SR 167/I-5 TO SR 509 – NEW EXPRESSWAY PROJECT DESIGN-BUILD PROJECT

Appendix C – Details of Technical Approach and Innovations

ATC #3 – NB I-5 Alignment Shift for MOT

ATC 005 Rev2 – Response to WSDOT Review Comments Round 2

- Please clarify that the existing SB I-5 Hylebos Creek Bridge widening is a permanent widening.

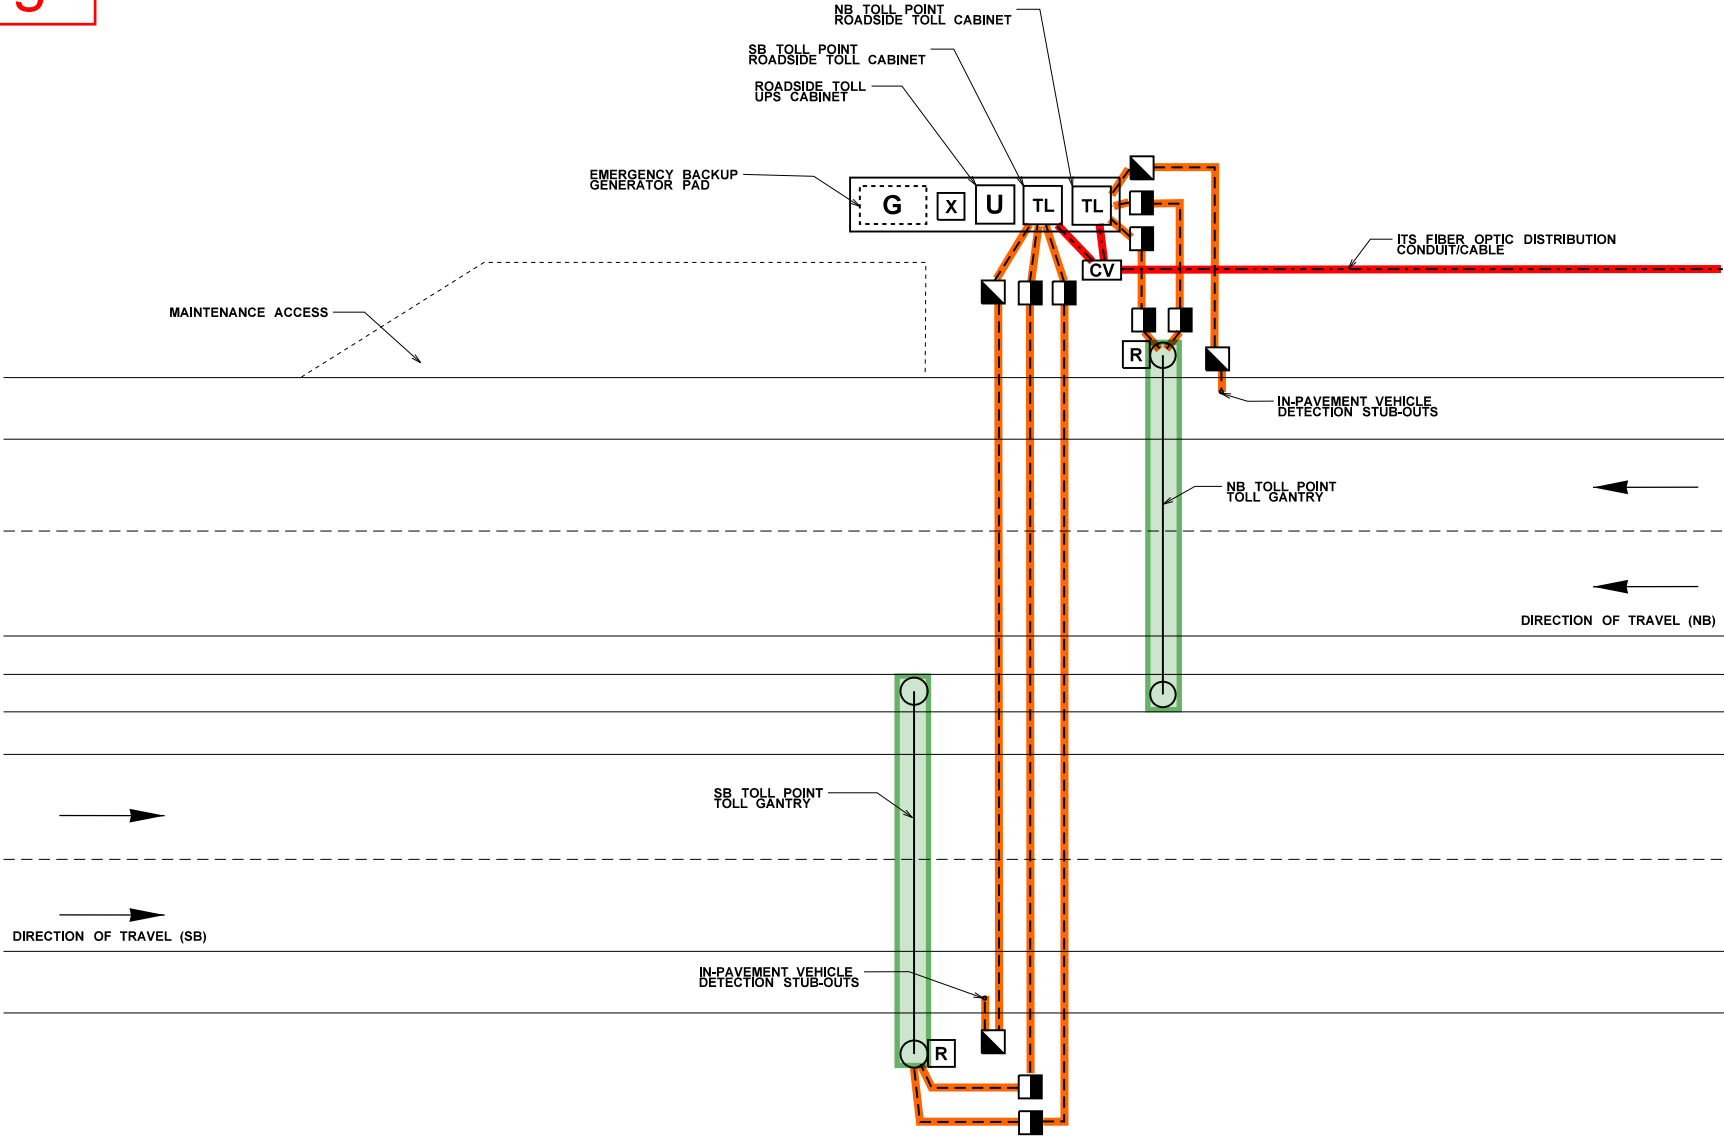
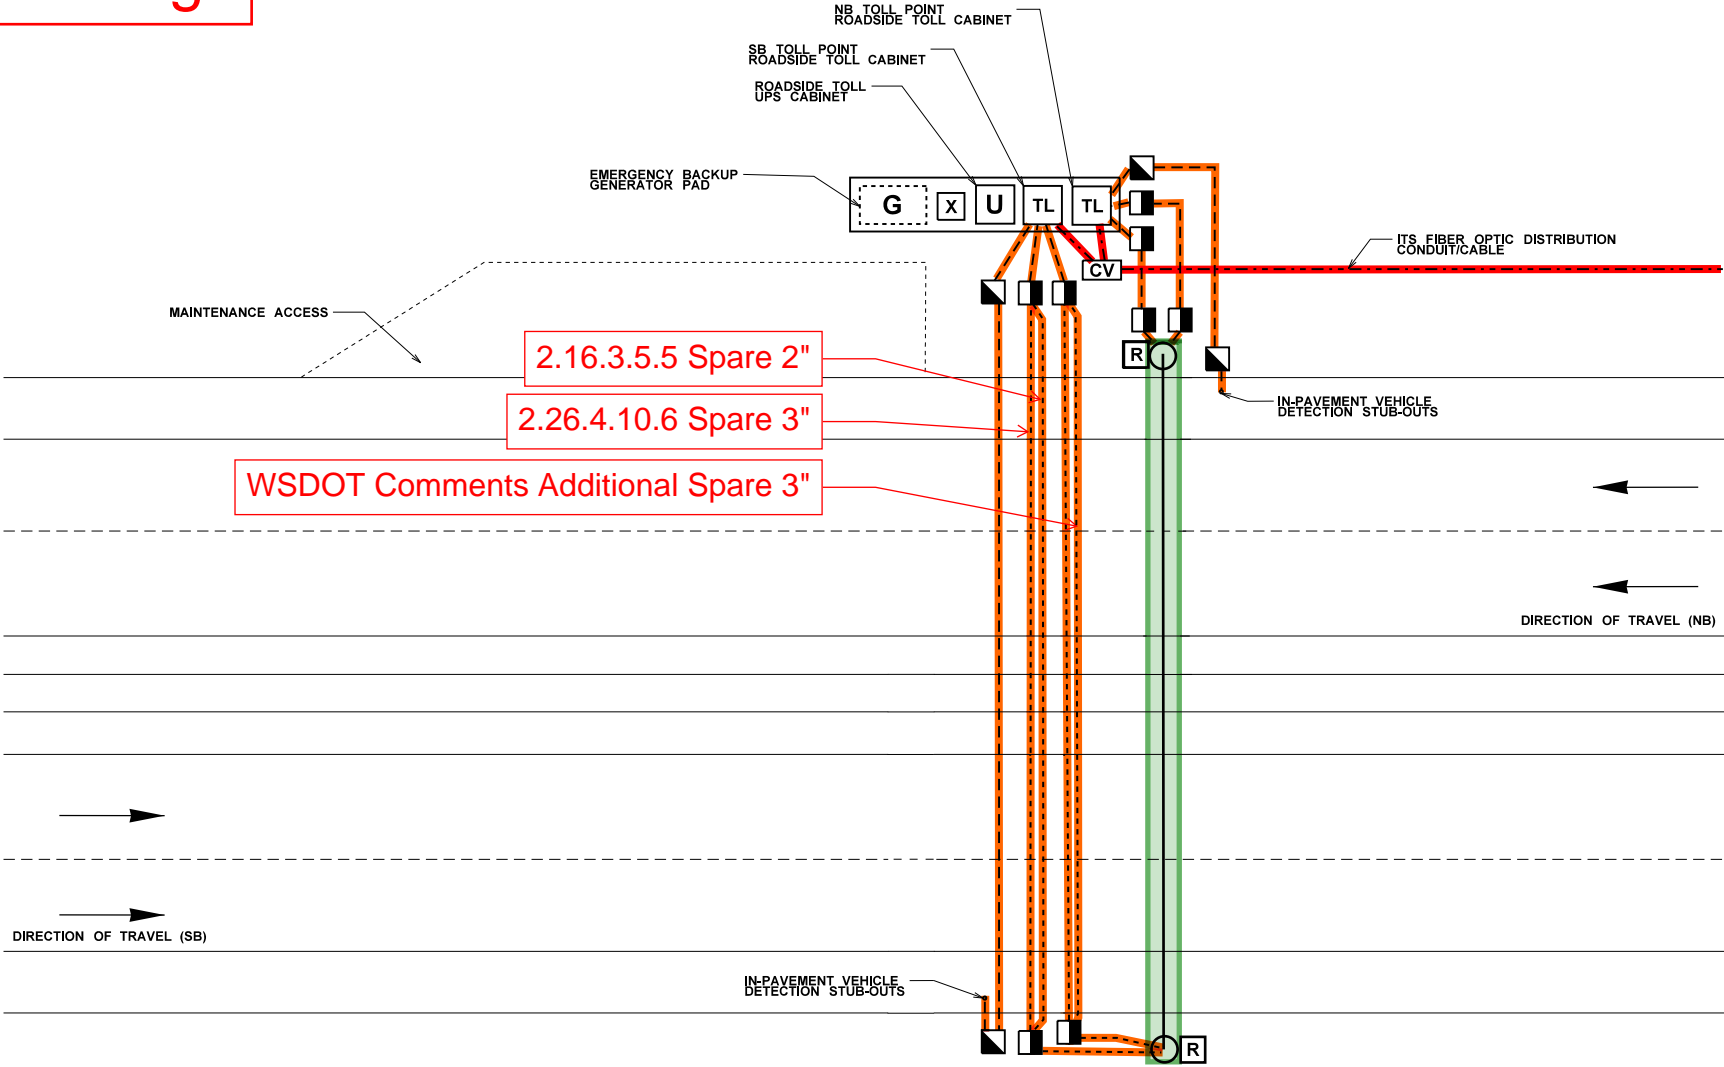
Brief Description: Replacement of the two gantry tolling system shown in the conceptual plans with a single gantry monotube sign bridge.

Detailed Description: The Design-Build team proposes to revise the basic configuration of the tolling infrastructure located along SR509 spur (509 S Line between station 46+00 and 49+00) between 8th St and 12th St from a dual toll gantry tolling system to a single monotube toll gantry tolling system spanning all NB and SB lanes.
